# Technical Memorandum

Project Title: Limited Amendment to the Clarksburg Master Plan

Subject: Draft Response to September 9, 2013 Geosyntec Letter

Date: October 15, 2013

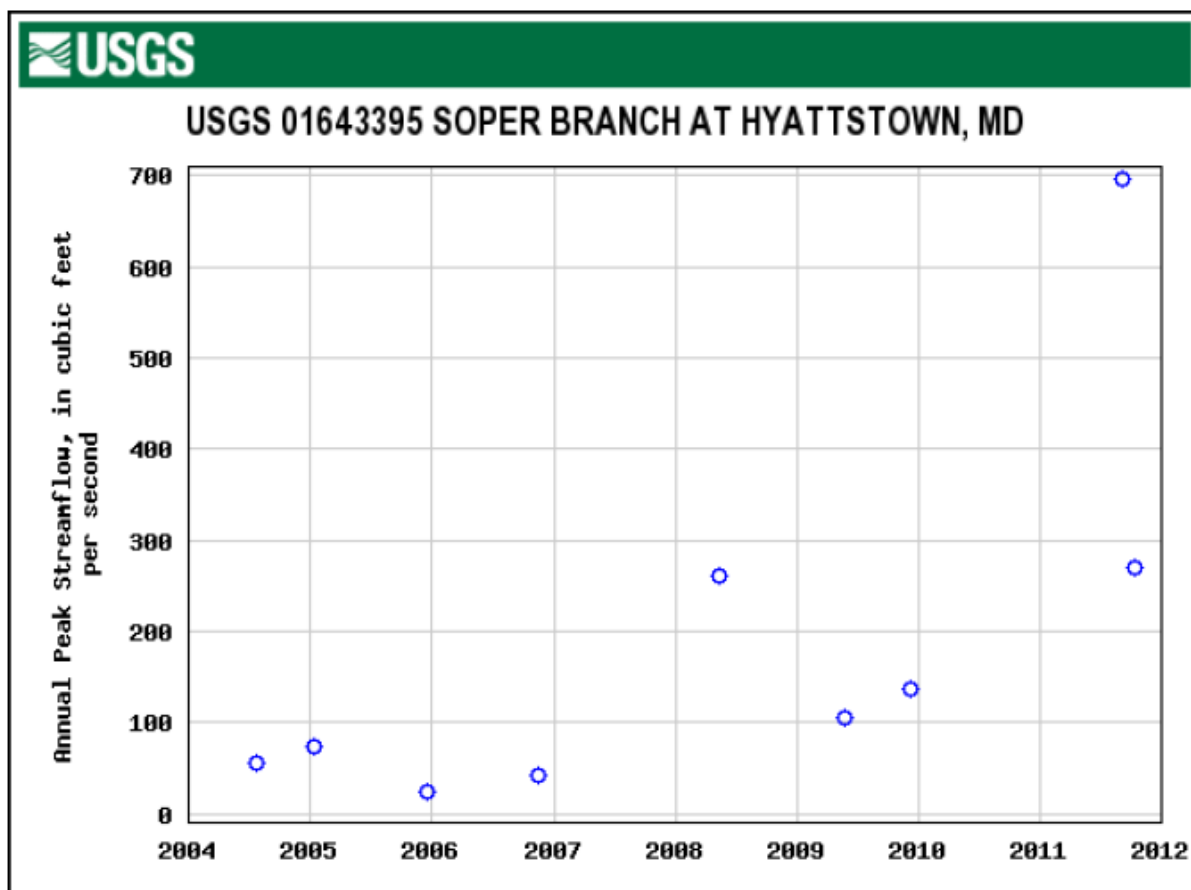
**Geosyntec Comment: Existing conditions model results are well outside of independent predicted results and norms for the area....The MNCPPC's consultant's model appears to grossly underestimate peak flow rates in LSTM110 and LSTM111.**

**Response:** We do not agree that the model grossly underestimated existing condition peak flow rates in LSTM110 and LSTM111.. Predicted peak flow rates are sensitive to various model algorithms and parameters, and can vary widely even within the range of accepted modeling methods and parameter values. The actual peak flow rates in LSTM110 and LSTM111 are unknown. Therefore, it is possible to arrive at different modeled predictions of peak flows under existing conditions. The Geosyntec comment letter cites three bases for comparison of predicted peak flows in LSTM110 and LSTM111:

The USGS Regression Equation quoted by Geosyntec is several years old. USGS has updated the regressions and present data on the USGS stream statistics web site ([http://streamstatsags.cr.usgs.gov/md\\_ss/default.aspx?stabbr=md&dt=130239302542270000](http://streamstatsags.cr.usgs.gov/md_ss/default.aspx?stabbr=md&dt=130239302542270000)). For a basin in the vicinity of the basins in question, this web site suggests a peak 2-yr flow of about 50 cfs for the 211-acre basin 110, which is greater than the value predicted by the Joint Venture but less than the value cited by Geosyntec. The Geosyntec model predicts peak 2-year flows twice the older USGS values and three times the more recent values.

Geosyntec used area-scaling from the Ten Mile Creek gage to validate their model results in continuous simulation noting that their model results were consistent with the area scaled peak flows during Tropical Storm Lee (9/8/2011). This gage is measuring flows from large areas of land use dissimilar to the largely undeveloped land uses found in LSTM110 and LSTM111 and a simple area scaling may be inappropriate. That aside, a better comparison may be achieved if the model outputs were contrasted with the full gage record so that smaller events nearer a one or two year occurrence could be assessed.

Much lower peak flows might be estimated if the area-scaling analysis used data from watersheds more similar in size and characteristics to LSTM110 and LSTM111. For example, the Soper Branch gage near Hyattstown, MD (01643395; [http://waterdata.usgs.gov/nwis/dv/?site\\_no=01643395&agency\\_cd=USGS&referred\\_module=sw](http://waterdata.usgs.gov/nwis/dv/?site_no=01643395&agency_cd=USGS&referred_module=sw)) measures streamflows from an undeveloped watershed of about 750 acres. Application of the area-scaling method to this gage would result in peak 2-year streamflow estimates for the 211 acre LSTM110 of 30 to 40 cfs. This estimate was made by taking the 4<sup>th</sup> largest annual peak flow in the area-scaled 9-year record. This represents a rough estimate because the record is relatively short, but it reflects the characteristics of the watershed. The Soper Branch data are shown below.
